8. Well Name and No
PLAINS UNIT #002

30-025-20040

PROPOSED PLUG AND ABANDONMENT PROCEDURE:

Permanent Abandonment of Federal Wells
Conditions of Approval

PLUGGING & ABANDONMENT WORKSHEET

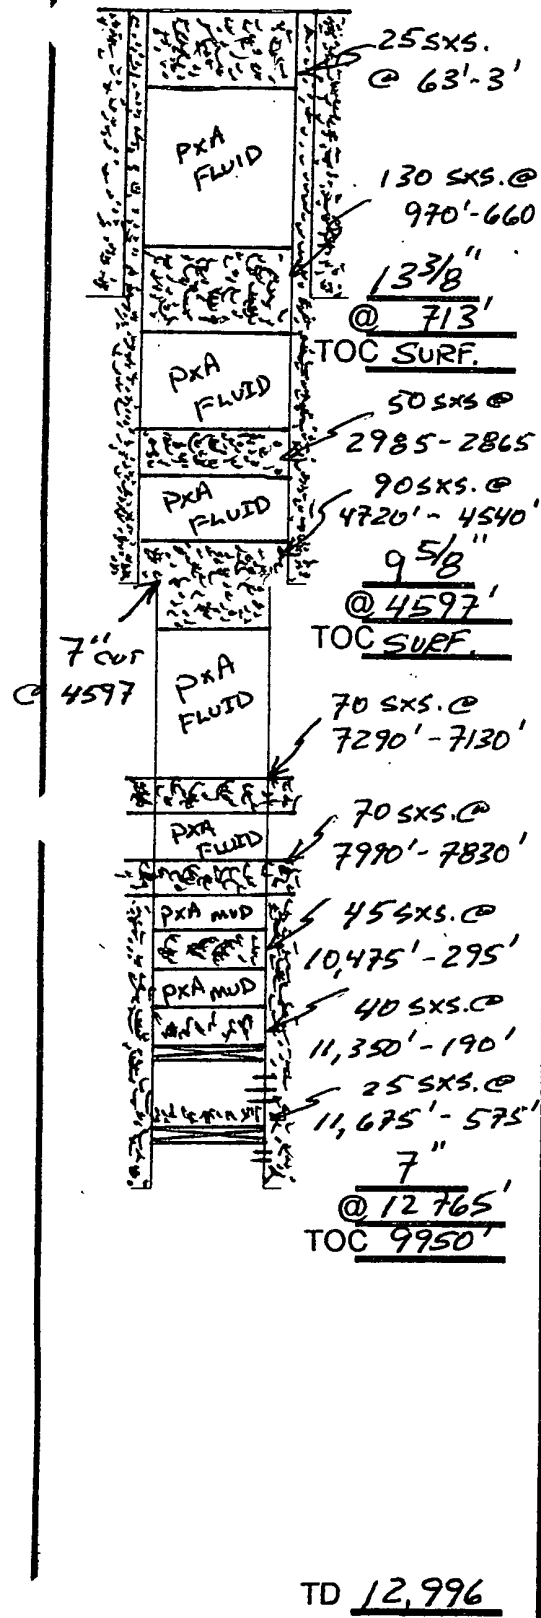
- 3) MIX X PUMP A 45 SX. OMT. PLUG @ 10,475'-10,295' (T/WC); ~~WOC X TAG TOP OF OMT. PLUG.~~ 210'
- 4) PERF. X ATTEMPT TO SQZ. A 70 SX. OMT. PLUG @ 7,990'-7,830' (7"CSG.LEAK). 180' WOC Tag

- 5) PERF. X ATTEMPT TO SQZ. A 70 SX. OMT. PLUG @ 7,290'-7,130' (T/BONE SPRINGS); WOC X TAG TOP OF OMT. PLUG.
- 6) CUT X PULL 7" CSG. @ +/-4,597'. 4672'

- 7) MIX X PUMP A 90 SX. OMT. PLUG @ 4,720'-4,540' (T/DILWR., 7"CSG. CUT X 9-5/8"CSG. SHOE); WOC X TAG OMT. PLUG @
- 8) MIX X PUMP A 50 SX. OMT. PLUG @ 2,985'-2,865' (9-5/8" DV TOOL). 130' WOC Tag 4522

* Add 120' plug 2660-2540' (Base Salt / Top / total) WOC Tang.

* Ground Level D.H.M
